Job Description: Kitchen Replacement
205 Bagot Street and 381 Bagot Street
Kingston, Ontario

Addendum No.: 1

ADDENDUM NO. 01

PROJECT: 205 AND 381 BAGOT STREET, KINGSTON ON
2020 KITCHEN REPLACEMENT

Figure 1: 205 Bagot Street - Drawing R2.4

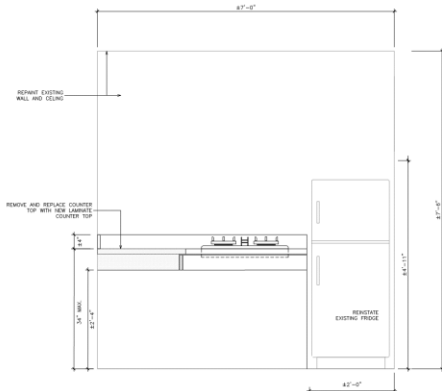
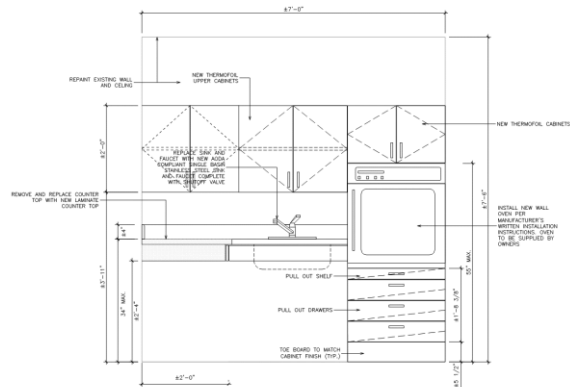
1. Flooring replacement at 381 Bagot Street is limited to the Accessible Units and the Caretakers Unit.
2. Revise upper cabinet locations in Accessible Units to remove upper cabinet above refrigerator and install additional upper cabinet adjacent to proposed upper cabinet and as follows:

Figure 3: 381 Bagot Street - Drawing R2.2

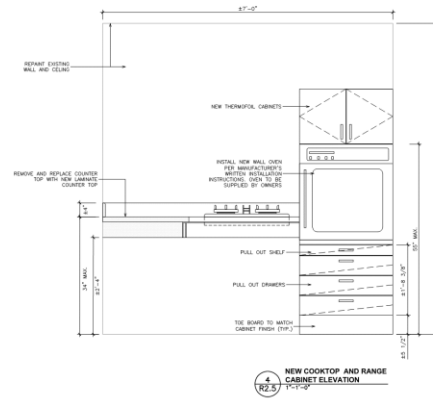
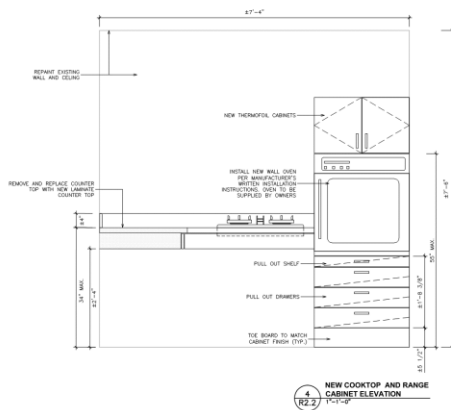
- .2 Revise upper cabinet locations in Accessible Units to remove upper cabinet above refrigerator and install additional upper cabinet adjacent to proposed upper cabinet and as follows:
